Re: Supplemental Comments on City of Tukwila Shoreline Master Program (SMP)
Update

We represent the James Campbell Co. LLC, which owns property in the City of Tukwila including four parcels along the Green River. This letter addresses an important issue that has been discussed during the City Council work sessions regarding the SMP: the circumstances under which the proposed 125-foot buffer in areas with levees could be reduced following reconstruction of a levee. We are proposing what we believe is a mutually beneficial solution on this issue. We trust that copies of this letter will be provided to the members of the City Council.¹

CROSS SECTION LAYOUT SHEET
GREEN RIVER BANK LEVEE
 GEOENGINEERS, INC.
 WASHINGTON
 CITY OF TUKWILA

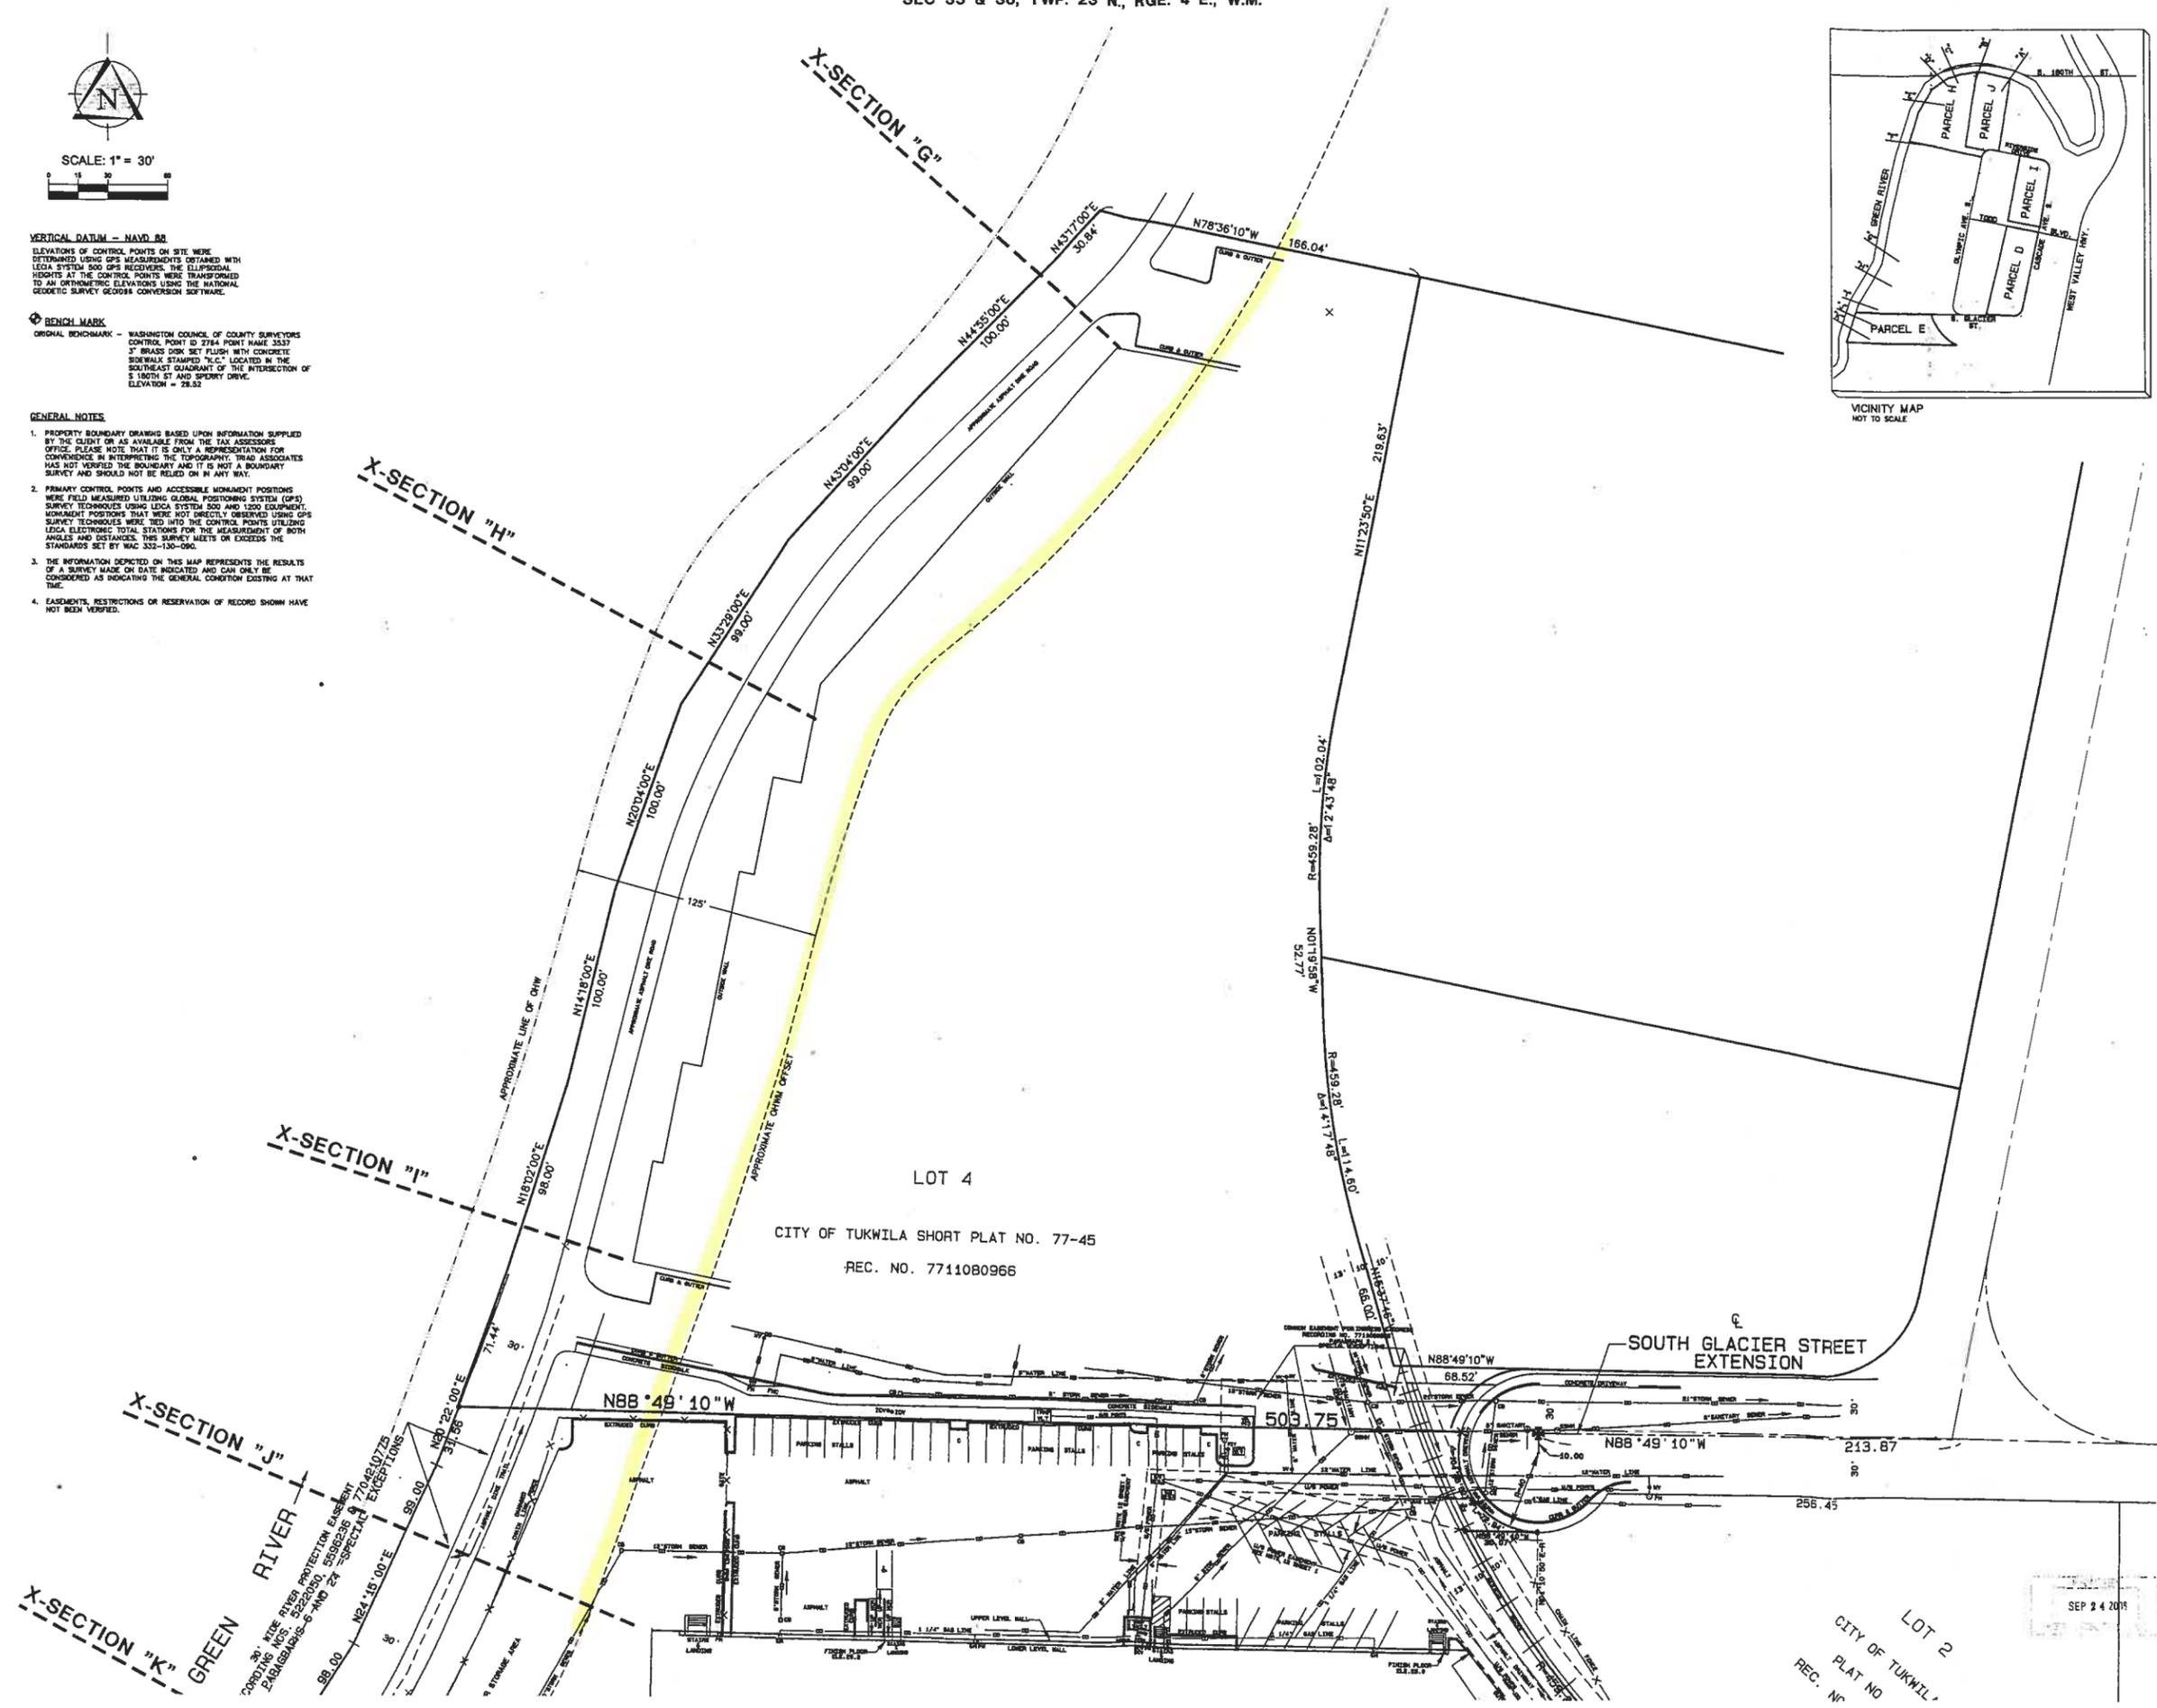
The proposed 125-foot buffer encroaches on existing buildings and site improvements on the James Campbell Company's property in a number of places. See Survey, attached as Exhibit A (the buffer line is highlighted in yellow). The proposed 125-foot buffer width reflects the City's estimate of the maximum width that would be required to accommodate reconstruction of a levee in conformance with the City's preferred levee "profile".² That profile includes a number of elements: riverside levee faces with a maximum slope of 2h:1v, a 15-foot-wide vegetated mid-slope bench, a 20-foot wide levee top, a landward levee face (e.g., backslope) with a maximum slope of 2:1, and a 10-foot access easement.

Figure 3

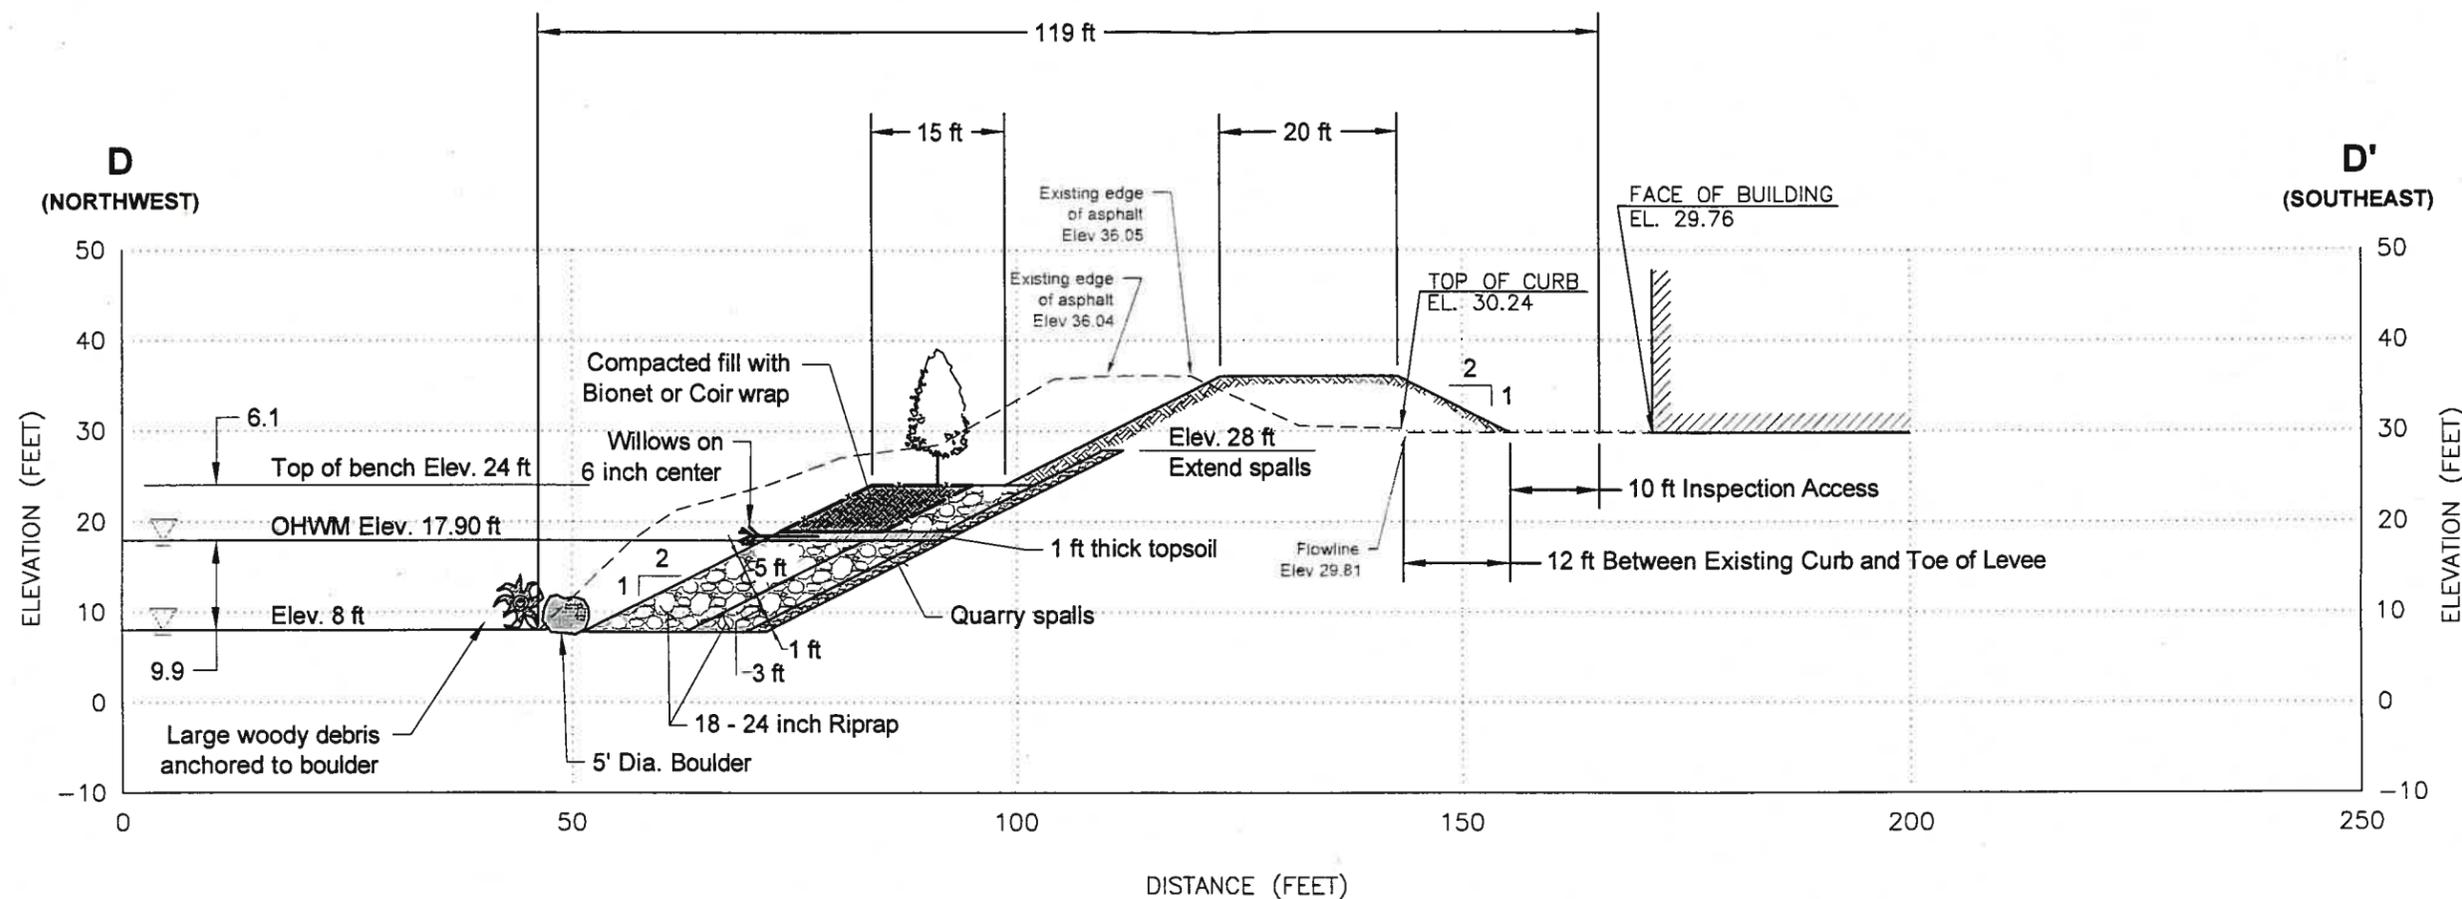
For example, at Conceptual Levee Section D, the City's profile would result in the levee backslope and access easement being located on a portion of the existing building access road, which provides access to building openings and parking. At Conceptual Levee Section E, the City's profile would result in the backslope and access easement impacting the existing building access road and a parking area that is needed to meet parking requirements. Most significantly, at Conceptual Levee Section F, the City's profile would result in the backslope covering the existing railroad line (without any room for a levee access easement between the backslope and the building).

However, there are alternatives to the City's profile that allow the City to achieve its key goals without impacting the existing improvements. For example, at Conceptual Levee Sections D and E, the levee access easement could be combined with the existing building access road. If the levee backslope left insufficient area for an adequate access road and parking, it might be necessary to use a floodwall in lieu of the backslope, reduce the levee top, or use some other alternative. More important, at Conceptual Levee Section F, the consultant determined that a "double" floodwall could be used to fit the reconstructed levee into the area waterward of the railroad line (assuming that the levee access easement could coexist with the railroad).⁵

Conceptual Levee Section I-I'
with Floodwall
 Green River Levee Site
 Tukwila, Washington
GEOENGINEERS
 Figure 2

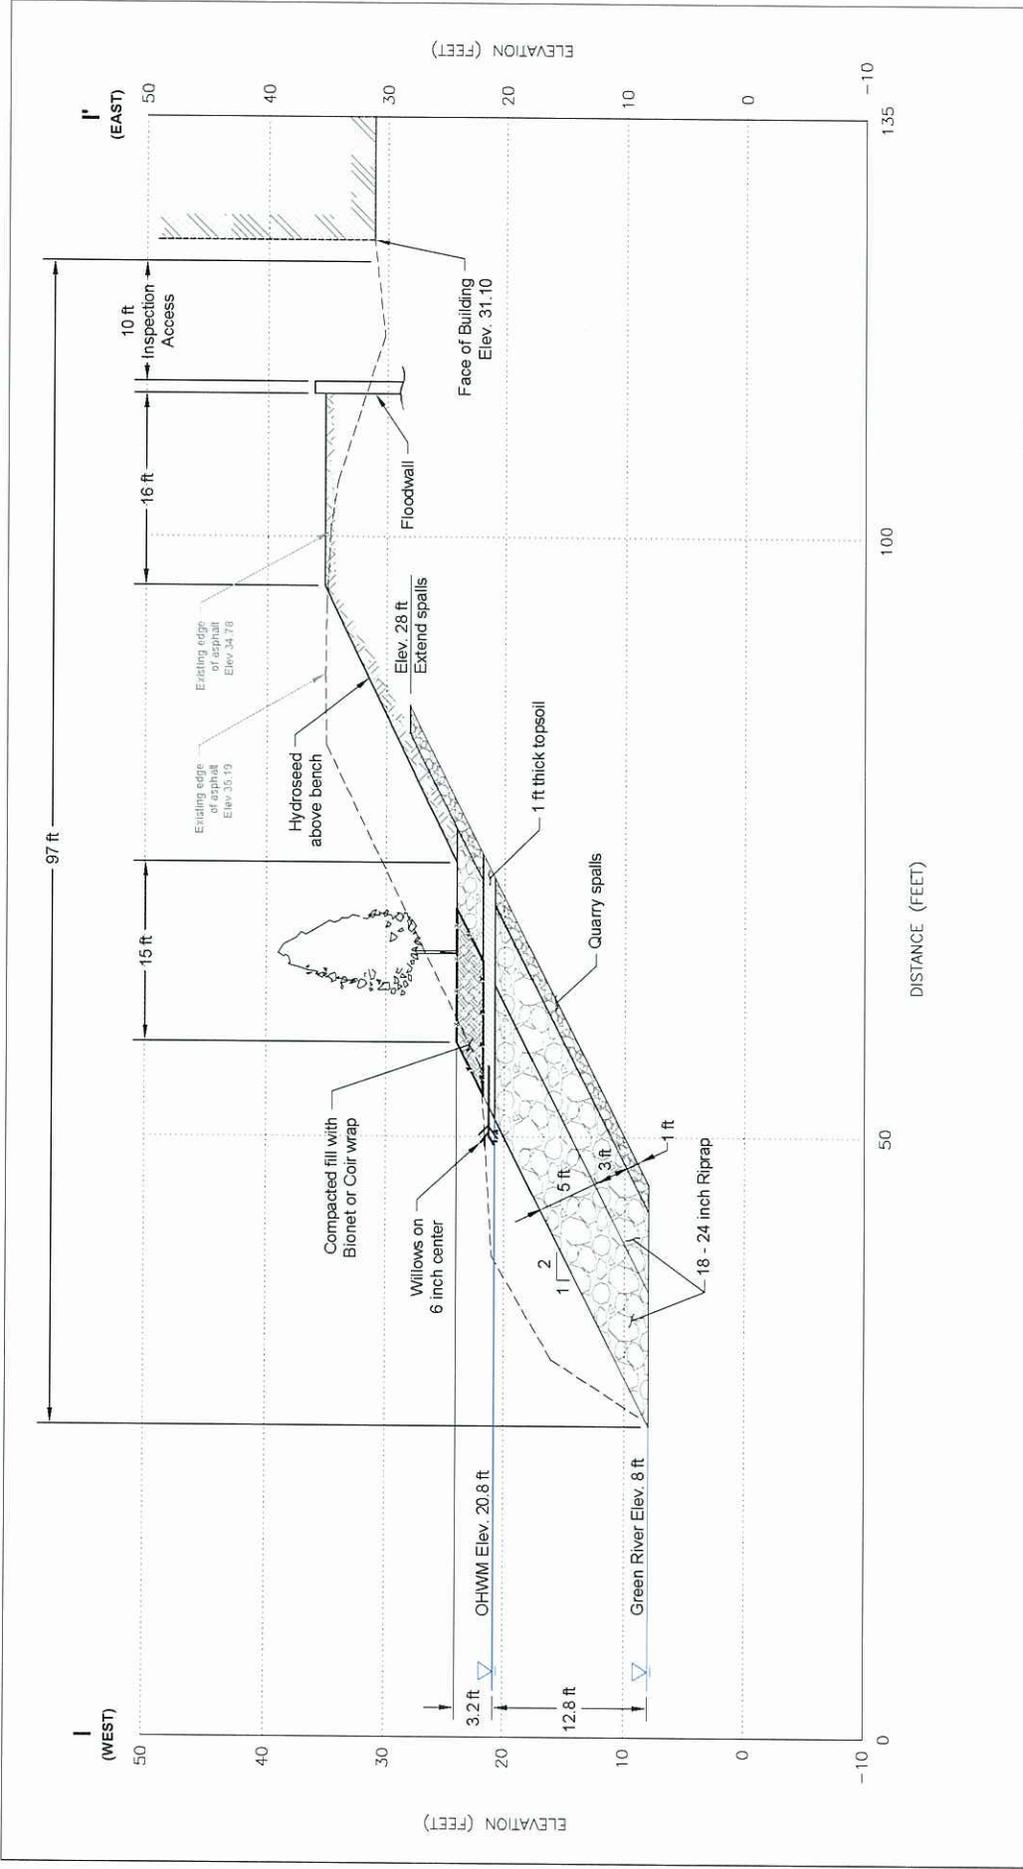
We developed a conceptual levee section for the levee adjacent to the Glacier Building, presented as Section I-I' on attached Figure 2. The specific location of Section I-I' is shown on the Triad survey previously submitted to the City. The conceptual levee section in Figure 2 is generally representative of the situation on the Glacier Building parcel as a whole.

Consistent with the SMP language in Figure 1, our conceptual levee section utilizes a floodwall in lieu of an earthen backslope in order to provide 10' clearance from the building. The only element of the City's "Preferred Levee Profile" not included in our conceptual levee section is an 18-foot wide levee top. Due to space constraints, a
